December 7, 2020

Shannon Hill, Planner III
Department of Planning, Building, and Code Enforcement
200 E. Santa Clara Street, T-3
San Jose, CA. 95113

Downtown West/Google EIR Comments.

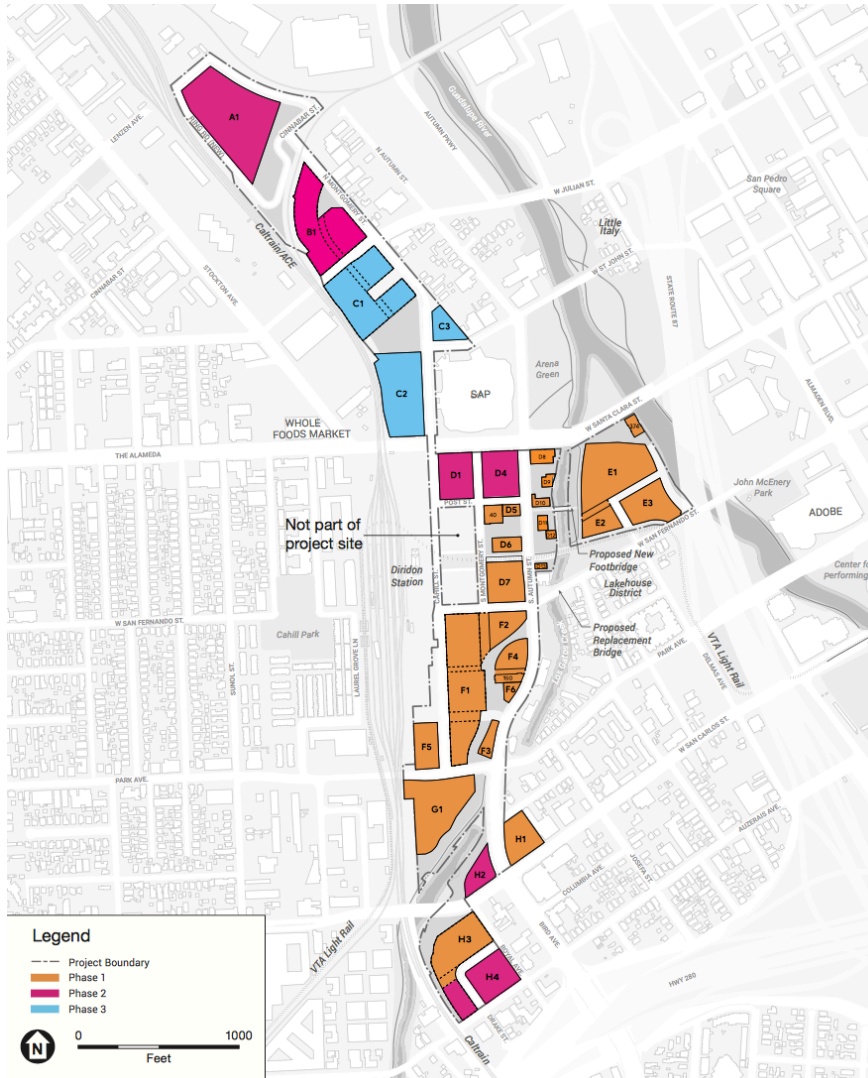
The following one is both grammatically awkward and/or incorrect and its intent is unclear.

Please explain the intention of this amendment. What, if anything, does this have to do with the Fire Training Center? Does this amendment grant permission for current parks to be destroyed for a private community gathering spaces such as a church, a new hockey stadium, or a music amphitheater? Would park conversion rules (ie requiring an election) still apply?

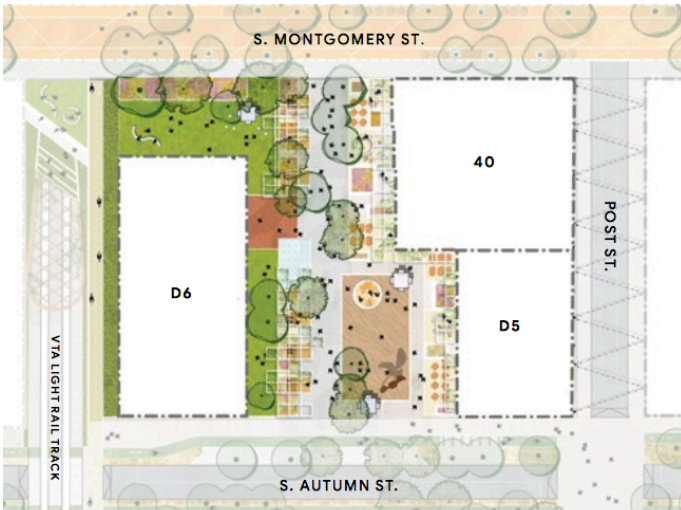
The **privately owned publically accessible parks “may have more limited hours of public access than City-dedicated parks”**¹¹ Nowhere is there a published statement of access. Will the public be allowed one day per week? One day per month? One day per year—like Grammercy Park in New York City? Will this property be closed for Google events, such as conventions or sales trainings or retreats? Who decides when it is open or closed? Who decides when it is *too*

limited? How does limited access promote equity, a key principle of both San Jose's General Plan Park policies and *Activate SJ*?
